Meeting Subject: Seward Airport Improvements Project (#Z548570000)  
Agency Scoping Meeting

## Seward Airport Improvements

PROJECT NAME: Seward Airport Improvements

SUBJECT: FEMA Policy on Water Surface  
Elevation Rise in a Floodway

# ALTERNATIVE 1.1

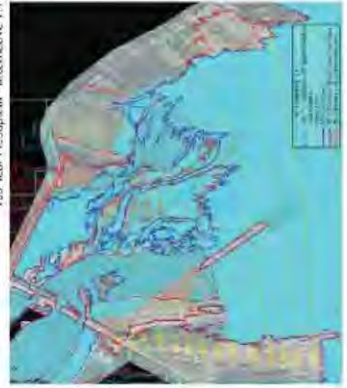
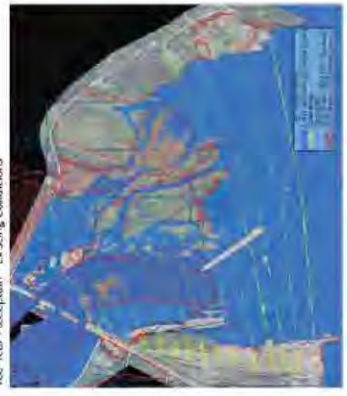
- Alternative 1.1 (PowerPoint slide 9) would keep the longer, main runway in its current configuration/alignment, but it would raise the embankment as much as 7 feet in some areas (4.4 foot average) to establish a final elevation 2 feet above the 100-year flood level (i.e. 2 foot of free board). Also, additional riprap would be installed to create a less permeable runway. The additional embankment and riprap placed in the floodway would cause an increase in the base flood elevation of as much as 4 feet.

- Modeled flood boundaries are identified for each Alternative (PowerPoint slides 9 and 10). Construction within the floodway (Alternative 1.1) would cause a rise in the base flood elevation by as much as four feet and the FEMA flood map would need to be revised as a result of the increase. Alternative 2.2 does not require construction in the floodway. As a

- Alternative 1.1, with the longer runway, would require substantial more erosion protection, which would involve the placement of fill within the river.

# ALTERNATIVE 2.2

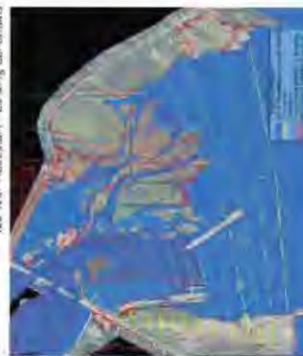
- Stephanie asked if the existing longer runway would be closed or removed.
  - For Alternative 2.2 (PowerPoint slide 10), the main runway would be closed, the pavement and lighting system would be removed, the embankment would remain to allow nature to take its course, potentially it would be eventually breach.

- For this alternative, the existing crosswind runway would be offset to meet standards, lengthened, raised above the 100-year flood level and protected with riprap.

- For Alternative 2.2, there are more wetland impacts, but there are no in-river water impacts. There is a pond near this alternative, a portion of which would be filled.

- Ginny Litchfield, ADF&G, said that, from a fish habitat perspective, the second alternative (2.2) is much more desirable.
- Alternative 1.1, because it involves fill within the floodway, will require revising the FEMA FIRM map. Fill from Alternative 2.2 would occur within the floodplain *but not* the floodway and would not require a FEMA Letter of Map Revision.
